PLANNING, ZONING, & BUILDING DEPARTMENT
PZ&B Staff Combination Memorandum: Architectural Commission and Town Council

SUBJECT: ARC-24-0128 (ZON-24-0093) 203 VIA VIZCAYA (COMBO)

MEETING: FEBRUARY 26, 2025 ARCOM
MARCH 05, 2025 TC

The applicant has submitted plans, entitled "PROPOSED NEW CONSTRUCTION: 203 VIA VIZCAYA" as prepared by **Solstice Planning and Architecture**, uploaded February 10, 2025.

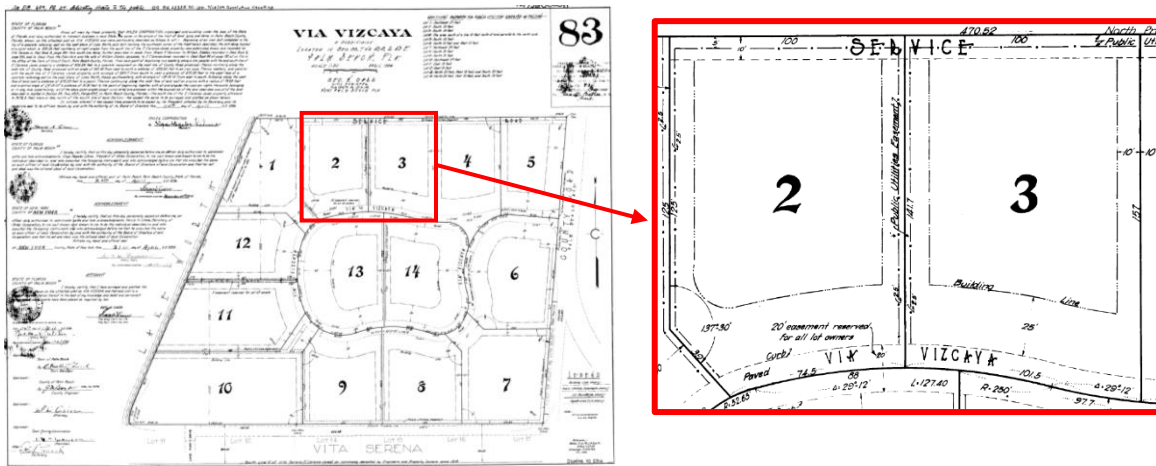
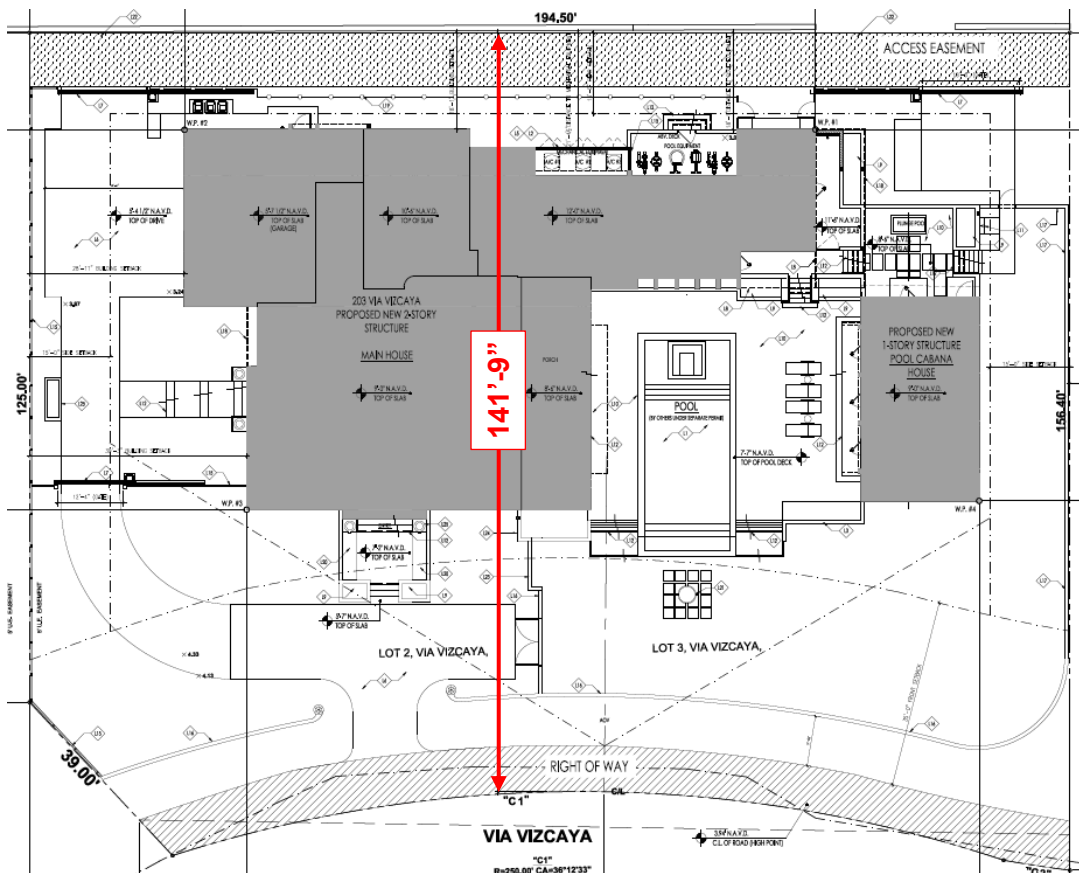
The application requires one Special Exception with Site Plan Review and one variance as designed. The need for a Special Exception stems from the existing configuration of the lot. The town's code prescribes the calculation of lot depth as "the distance from the midpoint of the front lot line to the midpoint of the mean rear lot line". Following the definition, the lot depth is 141'-9"

in lieu of the 150' required. The code does allow redevelopment of existing nonconforming parcels via the approval of site plan review or special exception.

Because this parcel is comprised of portions of platted plats (Lots 2 & 3 of Via Vizcaya plat, less the East 5.5 feet of Lot 3), the special exception is required.

Code Section	Required	Existing	Deficiency
Special Exception w/ Site Plan Review: Sec. 134-843(b)	Minimum Lot Depth of 150' in R-A Zoning District	141.75' Lot Depth	- 8.25'

PERVIOUS PAVING
SERVICE DRIVE

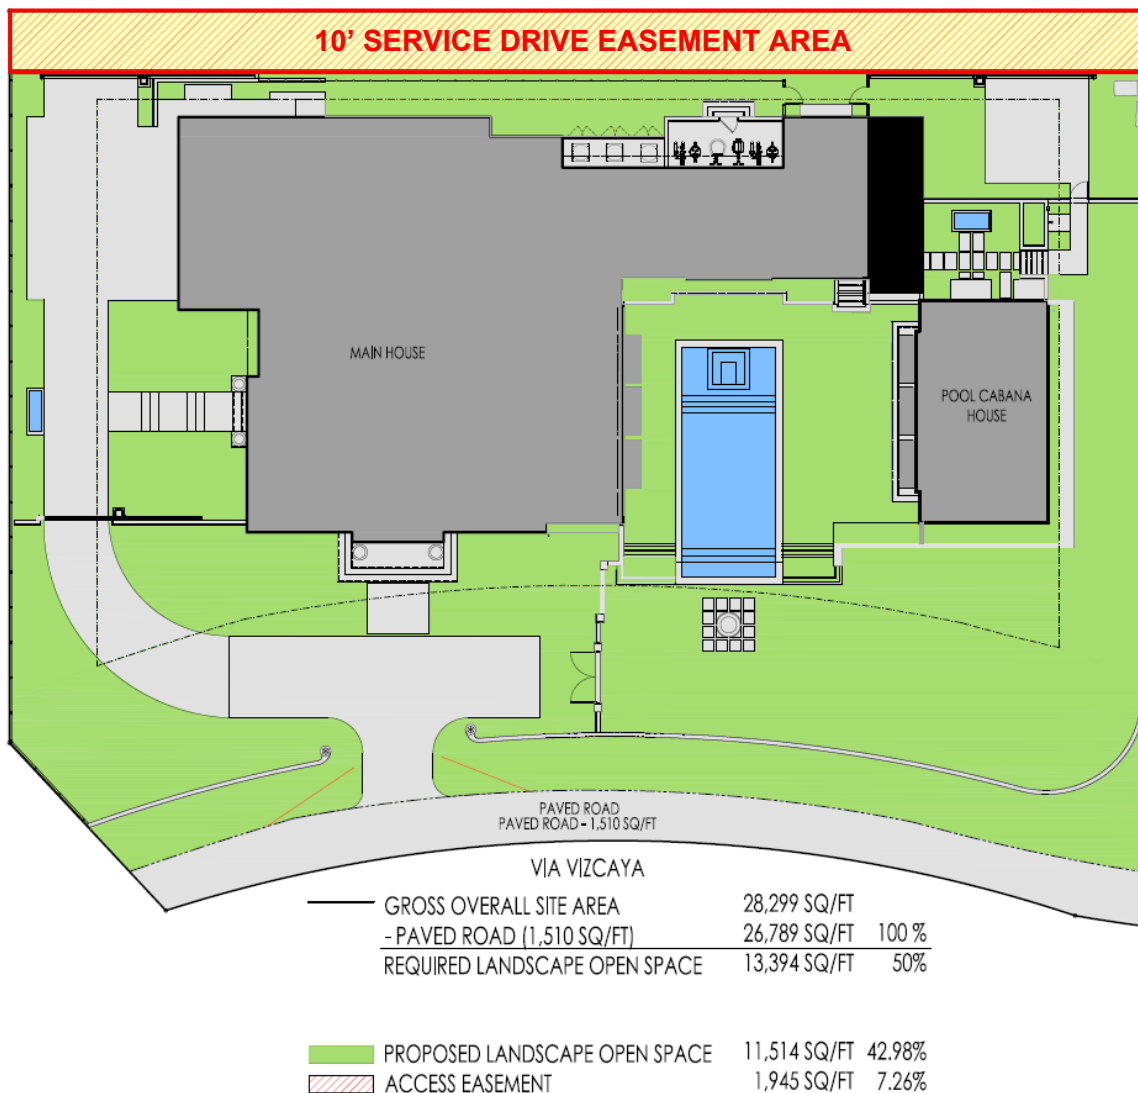
The variance requested is for reduced landscape open space. As shown on the survey, a 10'-0" wide "service road" easement existing along the northern span of the property. This easement begins at the parcel to the east of the subject parcel and provides access for the properties to the north and west. This area is included in the calculations when determining lot area, lot coverage and landscape open space. The applicant attests that if this area was not required to be included in the calculations, that the minimum landscape open space area of 50% would be met. The applicant does propose a pervious paver material across the service road in an effort to soften the effect of the variance.

Code Section	Required	Proposed	Variance
Variance 1: Sec. 134-843(a)(12)	Min Overall Landscape Open Space of 50%	Overall Landscape Open Space 45.68%	-4.32%
